Date: December 03, 2021

Declaration of change of WiFi PA

General: LIJI （RTC7639）is a variant product of Weixun（RTC7639）

MODEL NEME:Lenovo TB-J606L

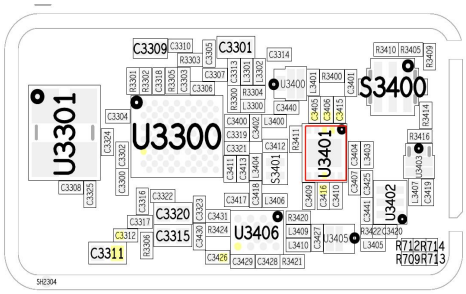
- Other changes detailed:
    ·After replacing PA, adjust the matching of the front and back ends to ensure the normal performance of the corresponding 5G WIFI after replacing 5G FEM.
    ·WIFI Power Amplifier Only Brand name change the specification is same, only the screen printing appearance is different.

Model	A	B
Brand	威讯 U3401	立积RTC7639

- As shown in the picture of the motherboard, the mark is the change point, which is pin to PIN.
  The corresponding circuit schematic diagram is not changed, and the bit number diagram will not change.
